13. Conditional Use-Final Site Plan: Cornerstone Condominiums, Phase II, 10165 South Redwood Road, 36 Units, R-M Zone. (Lynn Holt)

RE: Cornerstone Condominiums, Phase 2 Final Site Plan.

10. Final Site Plan Approval: Cornerstone Condominiums, Phase II, 10165 South Redwood Road, 36 Units, R-M Zone, Lynn Holt. Lynn Holt was present. Planning Director Ken Leetham presented this item. He stated that he and the applicant have met with the Public Works Department and the City Engineer on this phase and they are working with Mr. Holt to approve the culinary water plans. Mr. Leetham asked if Mr. Holt had a plat that the Planning Commission could review?

RE: Cornerstone Condominium Site Plan Review - Phase 2

CORNERSTONE CONDOMINIUMS PHASE 2  
10200 SOUTH 1500 WEST  
SOUTH JORDAN, UTAH  
LOCATED: SEC 10, T3S, R1W, S.L.B. & M.

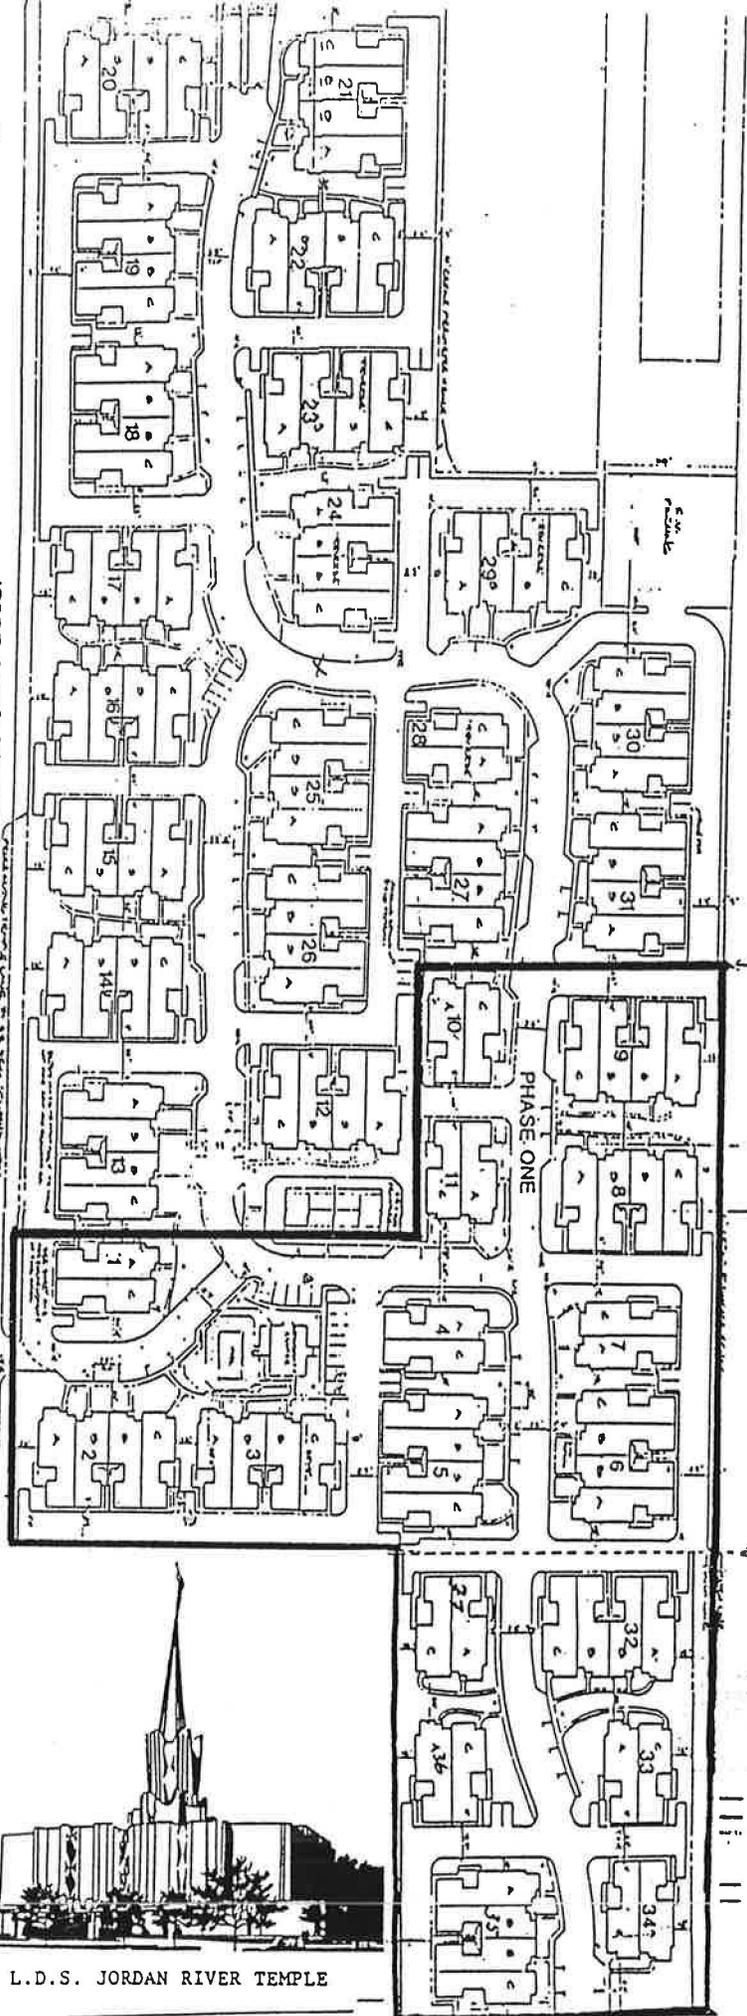
I have reviewed the two drawings that have been submitted for the Cornerstone Condominium project. I have redlined the drawings, and submitted them to Bush and Gudgell for corrections.

- Drainage arrows should be added to show the direction of the drainage.
- Inlet boxes should be added at locations where curb and gutter end. Draining the curb onto asphalt is not a sound practice.

- Combination boxes should be called out where curb inlet boxes are proposed over the curb, and the pipe is located adjacent to the curb. Four foot manholes with grates in the lid are not acceptable for curb inlets.

- Cast in place, or precast boxes shall be used where there are more than two pipes entering or exiting the boxes. Four foot manholes are not acceptable for large diameter pipe junctions, other than straight through flow.

- In areas where there is less than 2% slope, overland flow over asphalt is not recommended. Add concrete waterway to channel water, with 2% slopes to waterway.

- Check existing pipe, I remember an 18" pipe. If it is 18", extend it to the west to the junction with the line to the south.

- Submit to Sewer District for review and comments
- Add fire hydrants
- Field verify the existing 6" main, it should be an eight inch line that is to extend all of the way to Redwood Road.
- Washout assemblies are to be installed at the ends of the lines to allow the pipes to be flushed out.
- A six inch gate valve is to be located at the end of the line on the south. This valve will allow isolation during the testing and disinfection of phase three.
- Add detail of water meter vault.
- Show location of water meters.
- Installation of air valves should be investigated on the ends of the two inch lines.
- Blow offs should be installed on the two inch lines to allow the lines to be cleaned out and to aid in the removal of chlorine.

In addition to the comments above, fencing requirements, and lighting requirements should be discussed.
